ENGINE - INCORPORATION OF REDESIGNED ACC ACTUATOR REAR MOUNT BRACKET - CATEGORY CODE 4
- MOD.ENG-72-0074

- (1) Aircraft: Airbus A320
- (2) Engine: VC2500-A1 Engines, Serial No.V0014 through V0121

V2500-ENG-72-0074

Removal of old ACC actuator rear mount bracket (Before modification)
Fig.1

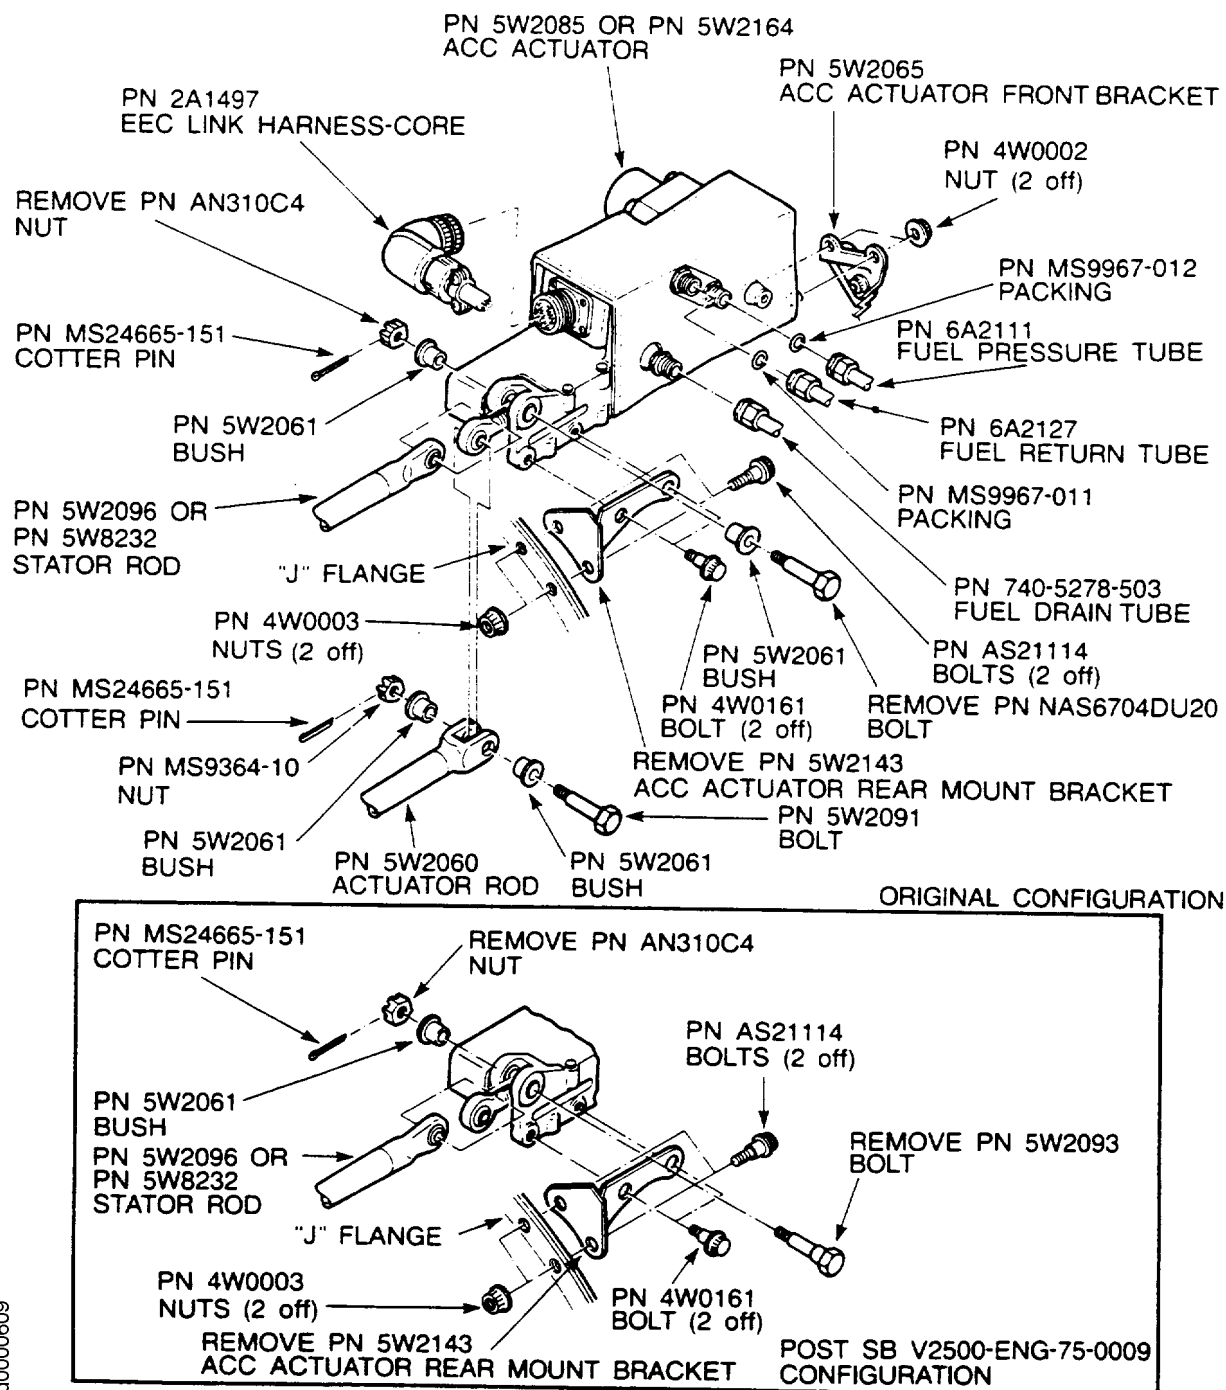
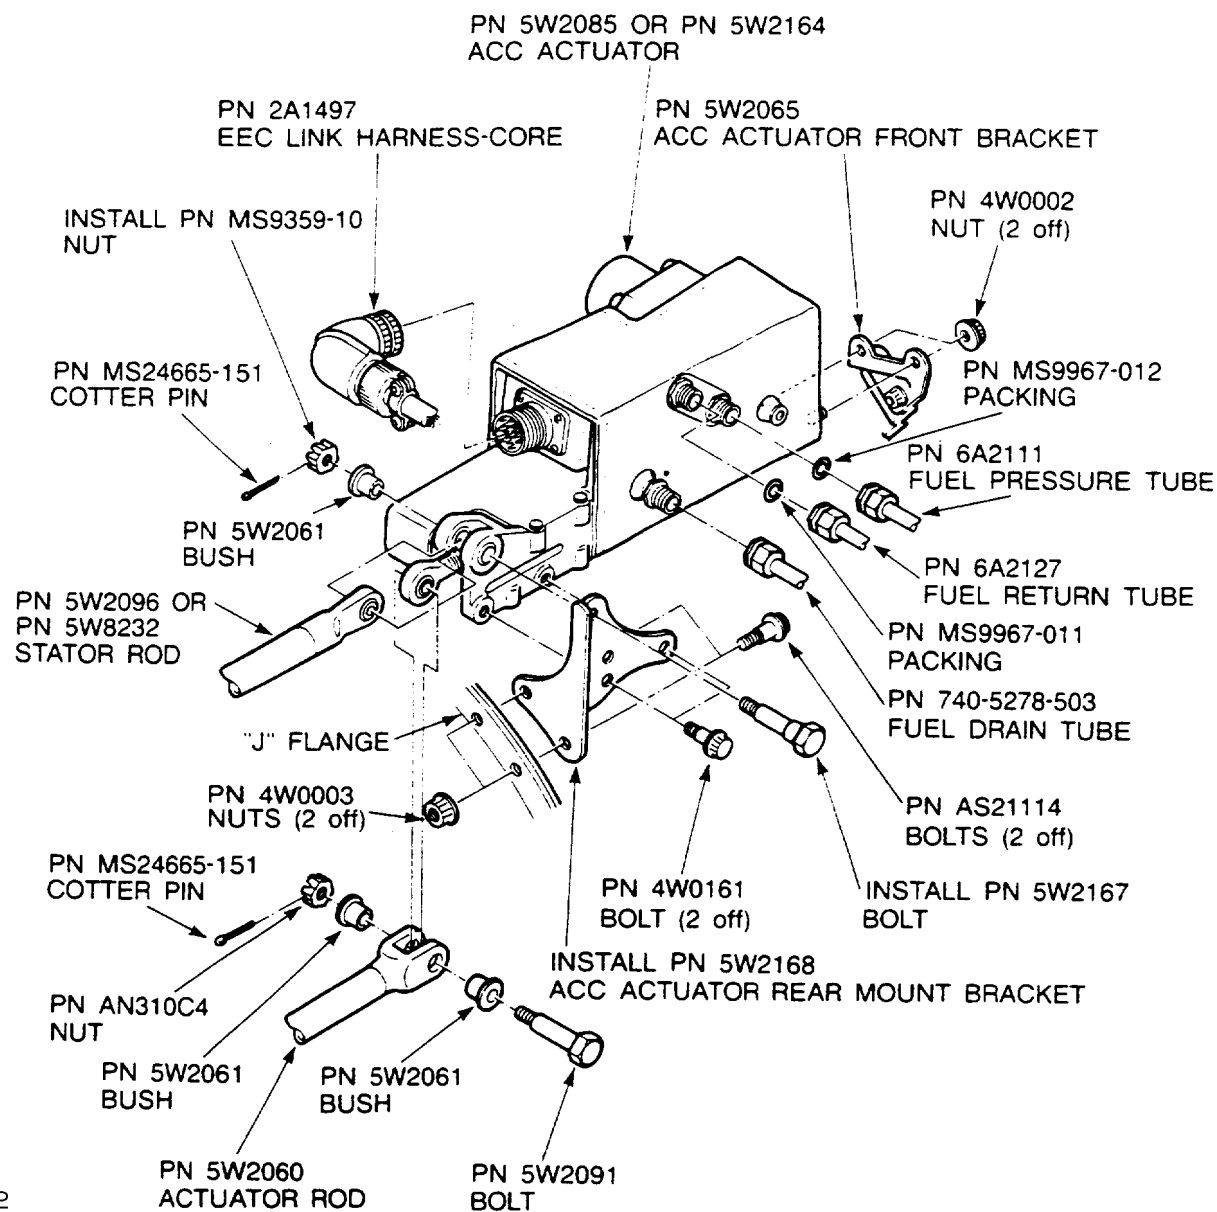
Some operators have experienced above condition. Reinforcement for the actuator body have been provided. New ACC actuator rear mount bracket changes two points support to three points support, requiring a new stator rod installing bolt.

- (1) The changes introduced by this Service Bulletin are as follows:
- (a) 5W2168 ACC Actuator Rear Mount Bracket supersedes old 5W2143 ACC Actuator Rear Mount Bracket.
 - (b) 5W2167 Bolt supersedes old 5W1093 and/or NAS6704DU20 Bolt.
 - (c) Quantity of 5W2061 Bush (75-24-51. 01-555) is reduced from two to one, (Pre S.B.V2500-ENG-75-0009 configuration).
 - (d) MS9359-10 Nut supersedes old AN310C4 Nut.

- (a) Remove two 4W0003 Nuts, two AS21114 Bolts and 5W2143 ACC Actuator Rear Mount Bracket.
- (9) Install 5W2168 ACC Actuator Rear Mount Bracket.
- (a) Attach 5W2168 ACC Actuator Rear Mount Bracket to the "J" flange.

- (b) Install two AS21114 Bolts and two 4W0003 Nuts.
- (c) Torque the two nuts to 180 to 220 lbf·in (20,0 to 25,0 Nm).
- (10) Install the 5W2085 or 5W2164 ACC Actuator.
